**SPLIT ROCK LIGHTHOUSE STATE PARK
CAMPGROUND EXPANSION PROJECT**

**WRITTEN COMMENTS RECEIVED DURING
EAW PUBLIC REVIEW AND COMMENT PERIOD**

**SPLIT ROCK LIGHTHOUSE STATE PARK
CAMPGROUND EXPANSION PROJECT
RECORD OF DECISION**

**REVISED FIGURE 5.
SPLIT ROCK LIGHTHOUSE STATE PARK
CAMPGROUND EXPANSION – PROPOSED
DEVELOPMENT.**

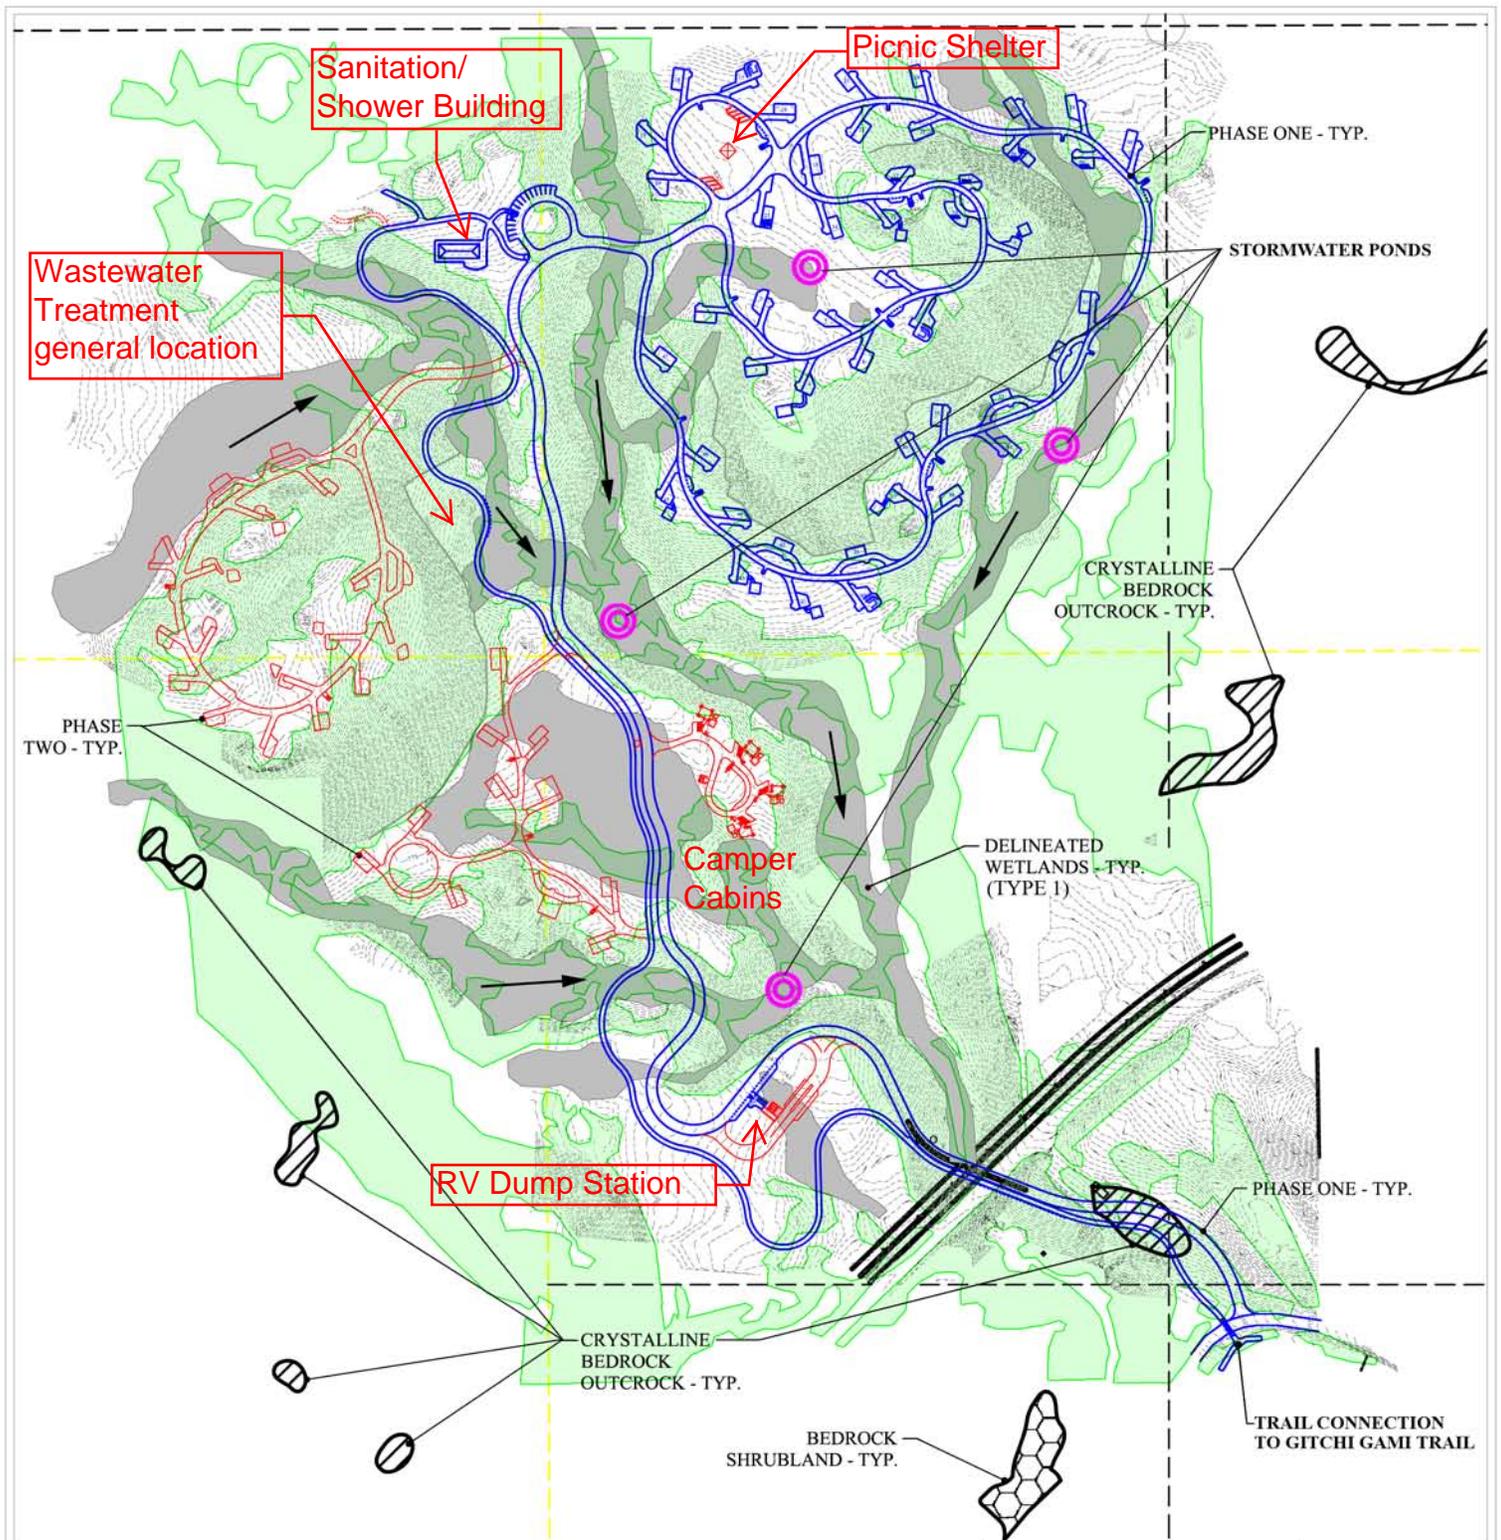
6. I wish to comment on Figures 2, 3, 4 and 5. In Figure 2, “Un-named Creek (S-031)” is labeled but not shown. I suspect the label compromises the depiction of the creek, had it been shown in characteristic symbology for an intermittent stream in blue color. This essentially limits determination of creek morphology. Lack of stream depiction occurs in Figure 4 as well. In Figure 3, the Project Area shown is half-way outside the State Park Boundary. Is this an indication of the earlier boundary before land was acquired for campground expansion? If so, please refer to opening statement about pre-determination of said project before public input. In Figure 5, I am confused by the differing texture below the light green shade to indicate slopes >12%. In some areas, the texture looks like elevation lines, yet that is inconsistent. If these are lines of elevation, I would like to be able to see indication of line values so I could determine direction of slope.
